IMPORTANT SAFETY RECALL – SN602
Safety Recall Notice 13V-089

Terex Utilities**SAFETY NOTICE****SN-602-13****DATE:** 3/5/13**REVISED:****TO:** Owners, Users, Dealers, and Installers**Models Affected:** XL4000 series of Digger Derricks**SUBJECT:** *Machinery Bushing 83725***Issue:**

Inspect here on lift cylinder

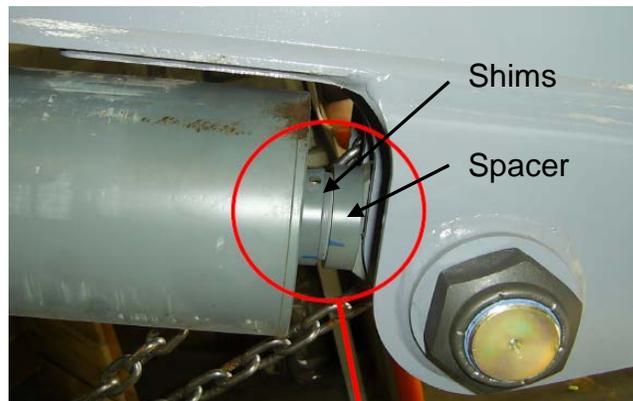
Terex Utilities has discovered that the metal shim, p/n 83725, used on the XL4000 series Digger Derrick lift cylinder has been supplied with the wrong material. The shim material is too soft and will compress with load which may result in fatigue in the threads of the rod eye. **If the rod eye threads fail the rod eye may separate from the cylinder and allow the cylinder and boom to fall.**

All XL4000 units require replacing the existing shims and spacer with one hardened spacer. Immediately inspect the preload on the cylinder rod to eye junction to determine if the shims are loose.

1. If the shim does not move when the boom is in the stored position you can continue to use the machine if you check the shim daily. Contact your nearest Terex Utilities dealer or Terex Utilities to arrange repairs within 60 days of receipt of this bulletin.
2. If the shims are loose and can be moved with the boom in the rest, you can continue to use the unit until repairs can be performed if the rod to eye is torqued to 500 ft-lbs and inspected daily until repaired. Schedule repairs within 30 days with Terex Utilities.
 - Procedure to tighten rod eye: Loosen the set screws on the rod then tighten the rod eye by turning the rod. You do not need to un-pin the cylinder. Tighten the rod eye to 500 ft-lbs and retighten the set screws to 15 ft-lbs. Inspect the shims for looseness daily. If they loosen again take the unit out of service and contact TEREX Utilities
